SEWAGE DISPOSAL SYSTEM

SUBDIVISION Sand Hill Acres LOT 12 ROAD 12026 Lamplighter Drive

RE: Sand Hill Acres, Lot #12
12026 Lamplighters Drive
Well Permit #HO-88-0668

DESIGNED JME	SITE DEVELOPMENT PLAN LOT 12 SAND HILL ACRES SECTION 3 AREA 2 3RD ELECTION DISTRICT HOWARD COUNTY, MARYLAND	SCALE 1" = 50'
DRAWN PS BAL		DRAWING 1 OF 1
CHECKED JME		JOB NO. 94-109
DATE 3-22-96		FILE NO. 94-109X
		For: ALTIERI HOMES 3017 Red Branch Road Columbia, Md. 21045

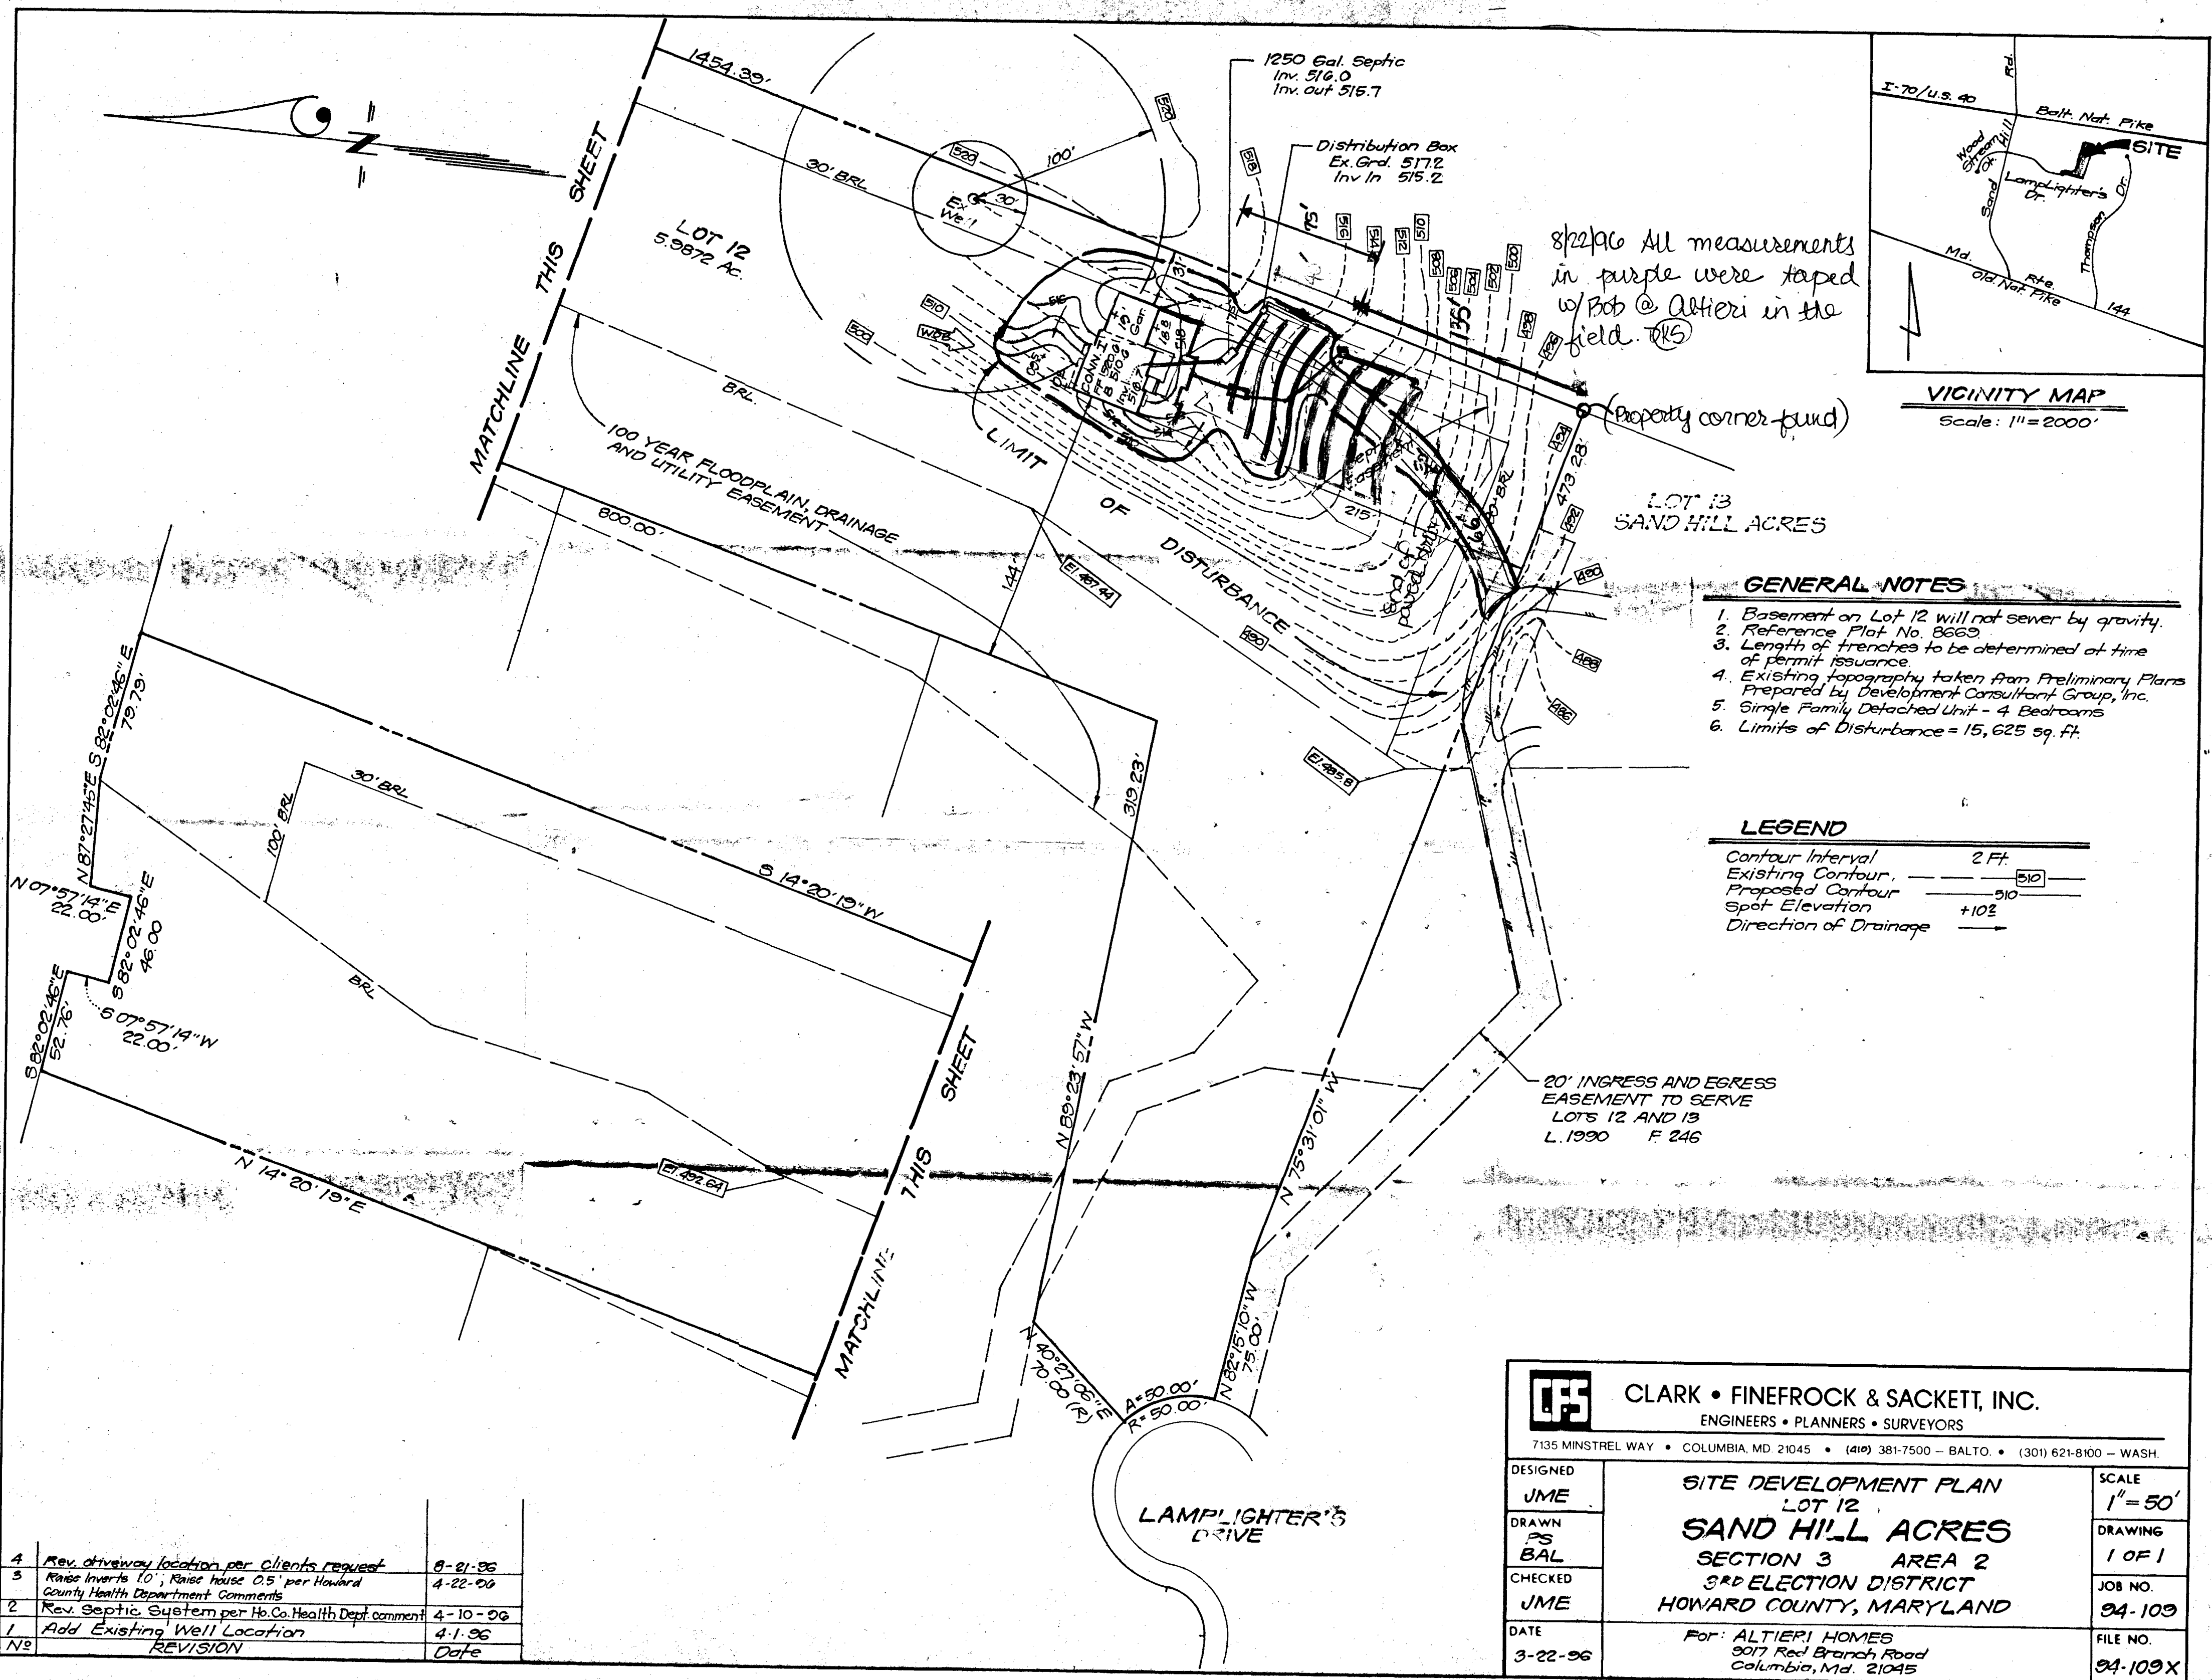
Site changes observed at the time of the inspection of the septic system installation brought about concern regarding the integrity of the future septic repair area. The existing and final finished driveway locations are obviously different than shown on the approved building permit site plan. Additionally, the final house location is uncertain. An attempt to resolve these concerns through a follow-up site inspection with the site superintendent on August 8, 1996 was inconclusive.

In order for these concerns to be resolved, a wall check drawing should be submitted to this office. This drawing should include the location of the actual driveway (both the existing and the proposed extension), the recorded sewage disposal easement, and the installed septic tank cleanout. Once submitted, the drawing should enable this office to determine whether or not the impact to the septic area has been sufficient as to require remediation. Field stakeout of the septic area could become necessary.

8/22/96 All measurements in purple were taped w/ Bob @ Altieri in the field. (KS)

No	REVISION	Date
4	Rev. driveway location per clients request	8-21-96
3	Raise Inverts 10'; Raise house 0.5' per Howard County Health Department Comments	4-22-96
2	Rev. Septic System per Ho. Co. Health Dept. comment	4-10-96
1	Add Existing Well Location	4-1-96

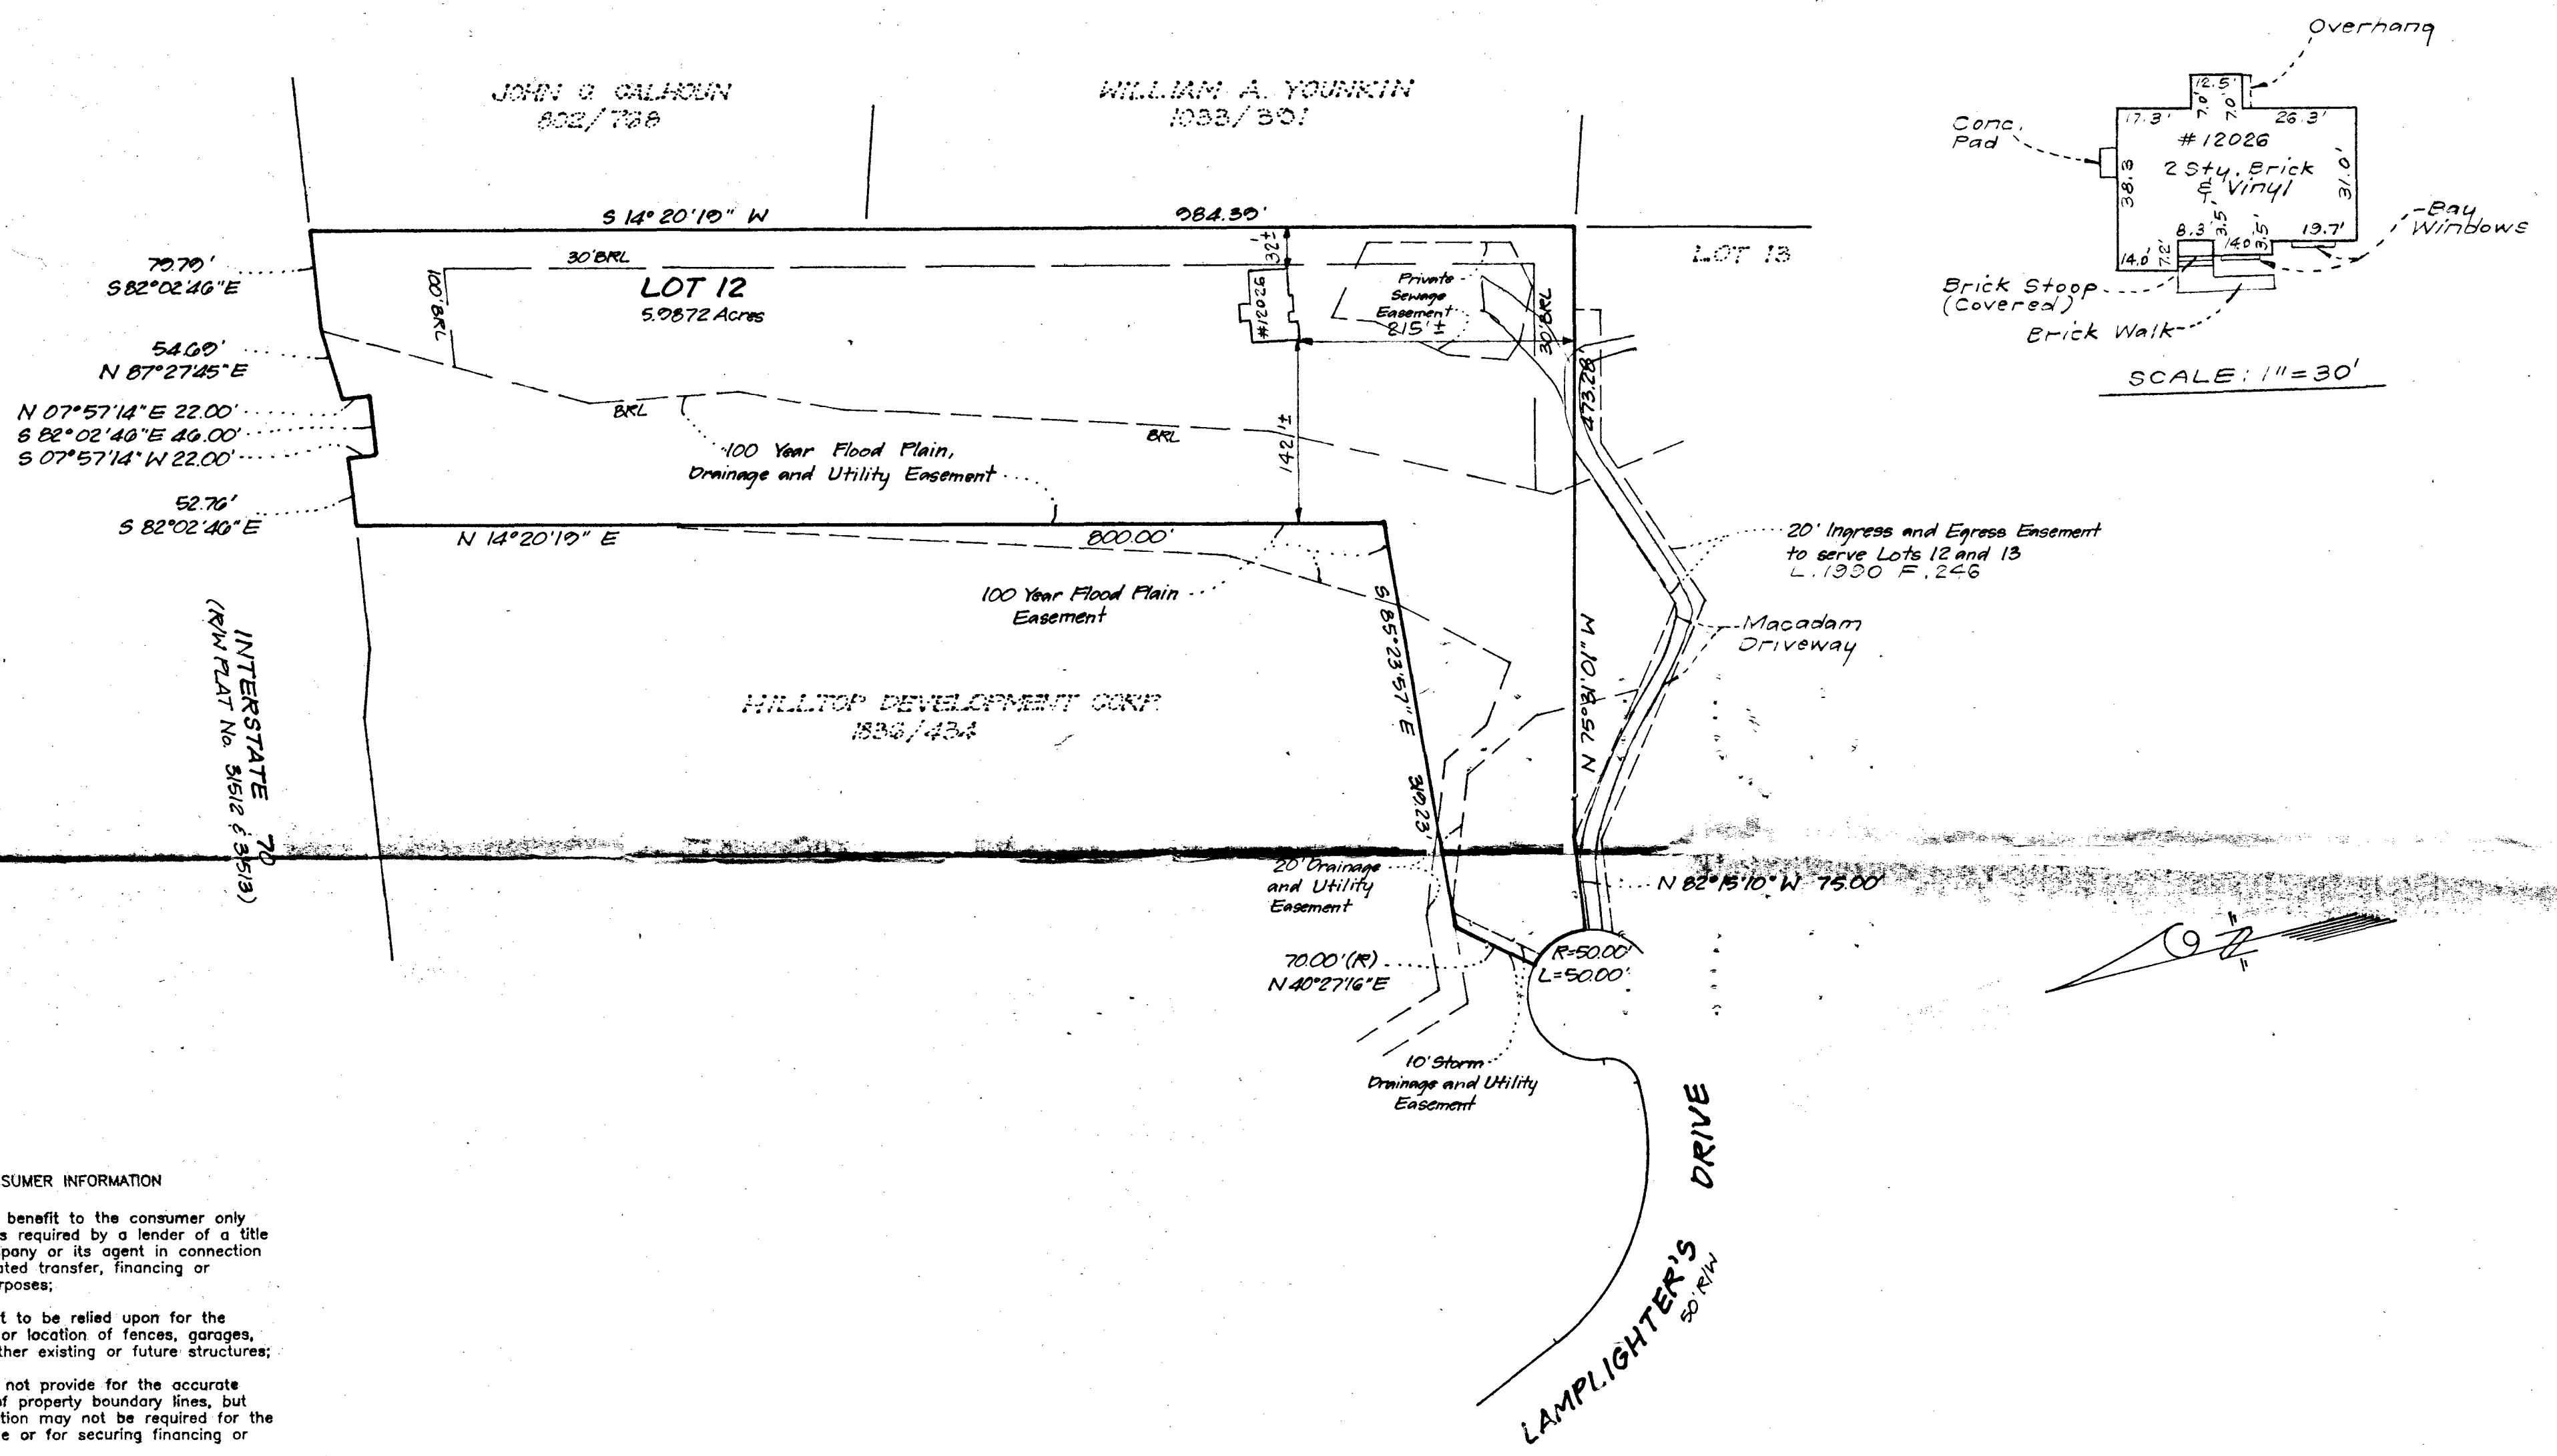
A site inspection was conducted August 22, 1996, to resolve issues of uncertainty regarding the above referenced property. The site inspection confirmed discrepancy between the approved building permit plan and site conditions. A letter dated August 12, 1996 described the necessary detail requested by this office to confirm actual field conditions. The drawing received, showing the revised driveway location, did not address the other items specified.

Please resubmit a wall check drawing including the detail described in the letter dated August 12, 1996. If you have any questions or concerns regarding this matter, please contact myself or Mr. Craig Williams at the address below or by calling (410) 313-2640.

1) no driveway
2) no st. cleanup
